SUNDRY NOTICES AND REPORTS ON WELLS

8. Well Name and No
SKELLY UNIT #964 (29742)

9. API Well No
30-015-34686

Conditions of Approval

12. Summary Drilling and Completion Program

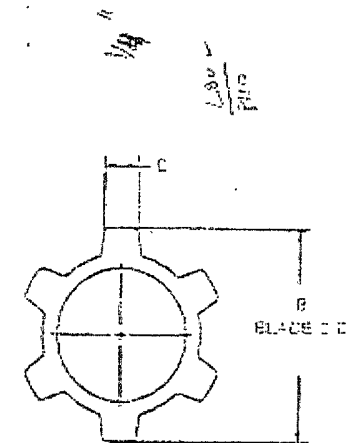
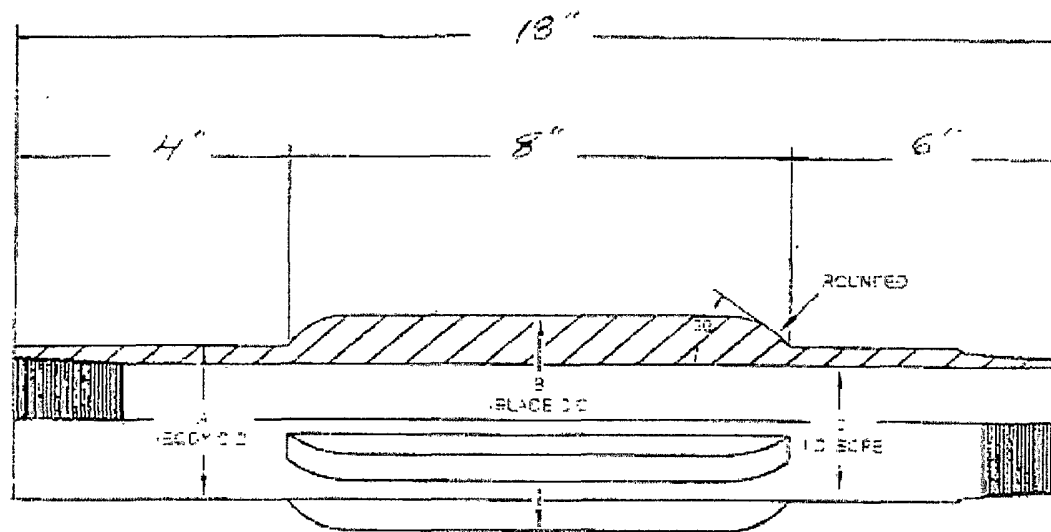
- d) Test casing as per Onshore Order 2.III.B.1.h.
- e) It is recommended that the top of the lead cement for the 4" casing be 100' minimum above the top squeezed shot, since the perforation length is extensive (178.5'), and there is no pressure testing or drawdown testing planned for the squeezed perforations.

- f) The planned depth for setting the DV tool should be revised to $\pm 4947'$, or shallower; which is above the top of the open perforations to be squeezed. By doing so, all of the squeezed perforations will be cemented behind the 4" casing. When plugged, a cement plug will be required across this tieback.

- h) The 4" casing will be backed off above the DV tool, now being located at $\pm 4947'$.
- i) If cement does not circulate from the DV tool, the appropriate BLM office is to be notified. In that event, Operator to recommend the alternate method of confirming TOC.
